NEF-06-00047-NRC

Louisiana Energy Services, L. P.  
National Enrichment Facility  
NRC Docket No. 70-3103

Subject: Revisions to Licensing Basis Documents

Enclosed with this submittal are markups of the affected pages as well as replacement pages for the documents along with page removal and insertion instructions. In addition, a revised copy of Safety Analysis Report Chapter 2 describing the organizational changes is enclosed for information only.

**FIGURE A1**  
LES CORPORATE, DESIGN AND  
CONSTRUCTION ORGANIZATION  
DATE: SEPTEMBER 2006

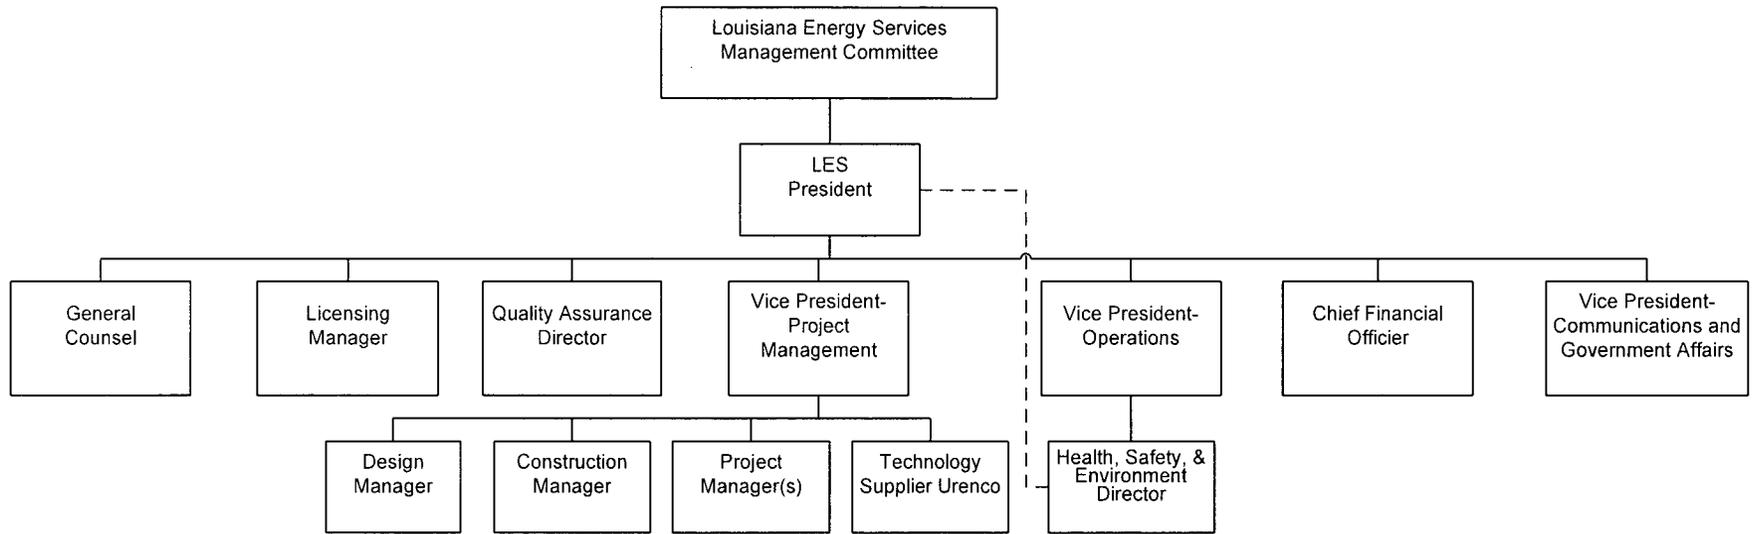
Louisiana Energy Services (LES) has made organizational changes that affect position titles and reporting responsibilities as described in several of the Licensing Basis Documents that were included in the application for the National Enrichment Facility license.

The LES ~~Engineering and Contracts Manager~~ Vice President - Project Management in coordination with the QA Director shall establish measures to routinely interface with the supplier and to verify supplier performance. The measures shall include:

~~LES Engineering and Contracts~~Project Management organization shall disposition the supplier's recommendation and verify implementation of the disposition. LES will maintain records of the supplier-submitted nonconformances.

**FIGURE A2**  
 LES NATIONAL ENRICHMENT FACILITY  
 OPERATING ORGANIZATION  
 DATE: SEPTEMBER 2006

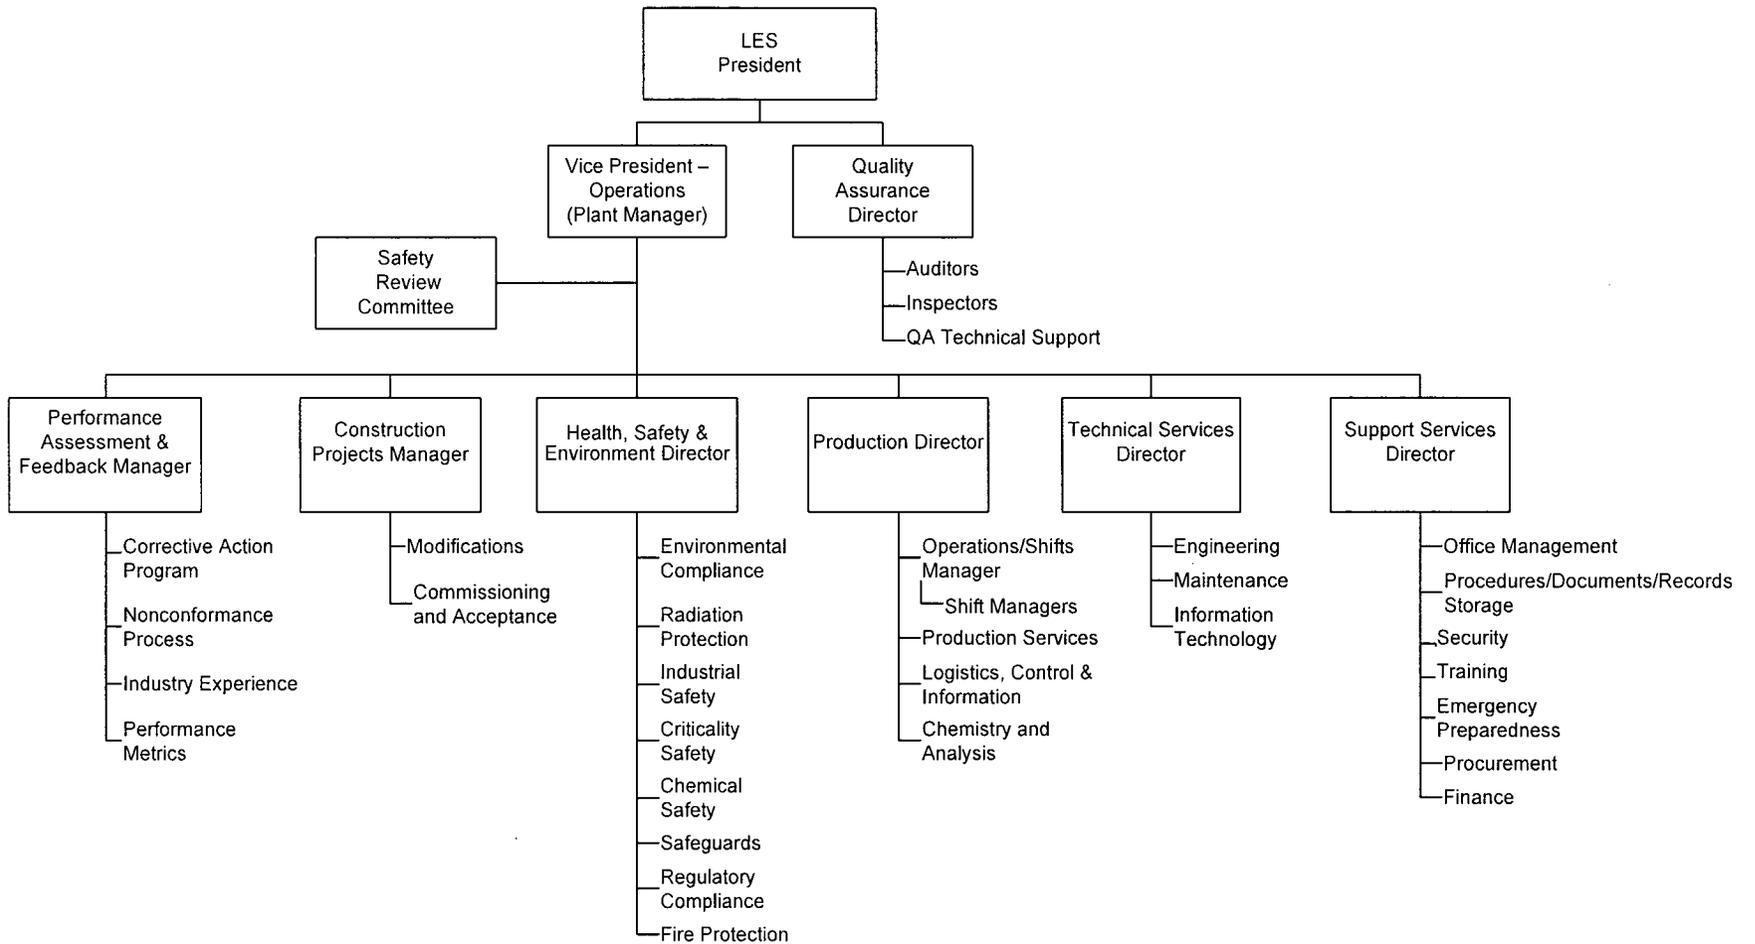
The operating organization is shown in Figure A2, LES National Enrichment Facility Operating Organization. The Vice President - Operations serves as the Plant Manager, and reports to the COO President. The Plant Manager and is responsible for the overall operation and administration of the enrichment facility. The Plant Manager is also responsible for ensuring the facility complies with all applicable regulatory requirements including the requirements of this QAPD. In the discharge of these responsibilities, the Plant Manager directs the activities of the following groups.
